SERVICE BULLETIN

2 µF STARTING CAPACITOR

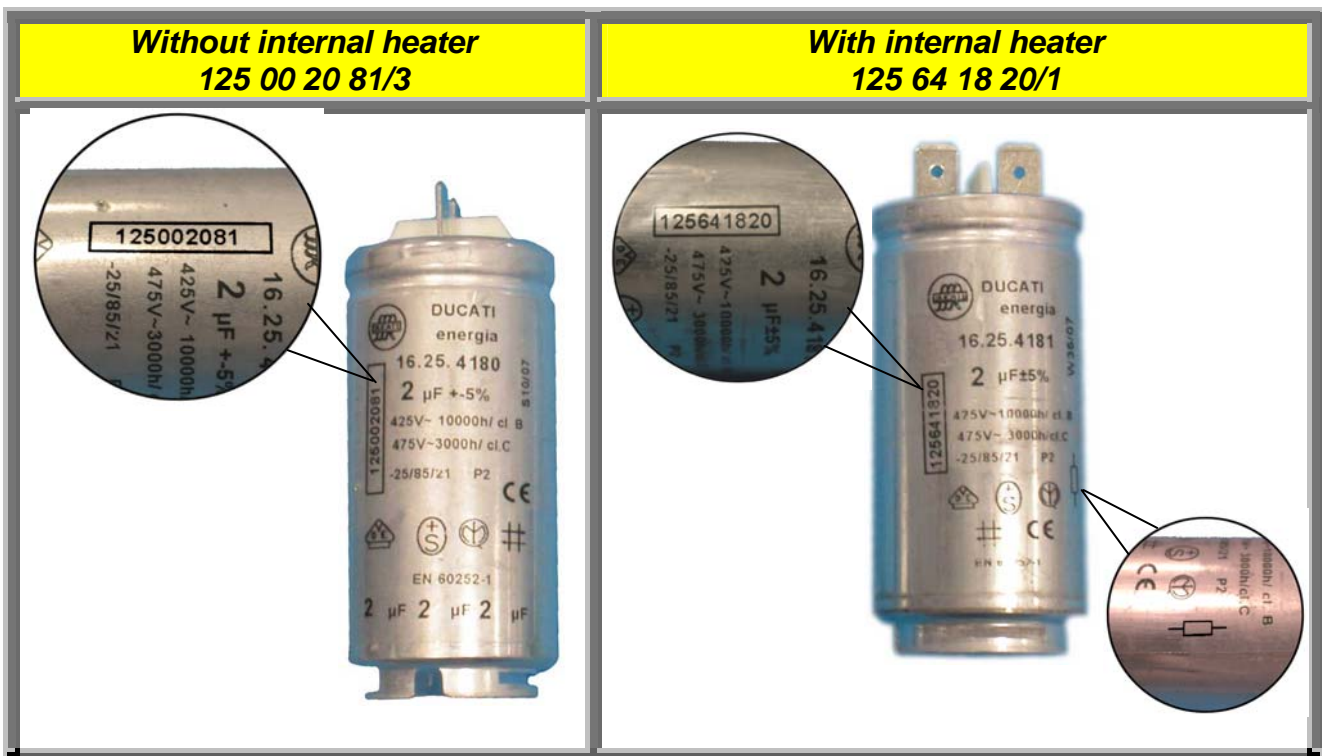
In the Siewierz factory (Poland) some B class dryers have been produced with an additional 2µF starting capacitor with an internal heater which discharges it when it is not used. This modification has been carried out to prevent the starting capacitor from remaining charged and being damaged afterwards.

Except for the ENV06 models, all condensed B class dryers that feature the 2 µF starting capacitor. The two capacitors can be identified by the part no. and the symbol of a heater printed on the sides.

In case of replacement of the capacitor, please pay attention to the type of spare part used. It is necessary to order the part no. **125 64 18 20/1** or following slashes having the internal heater.
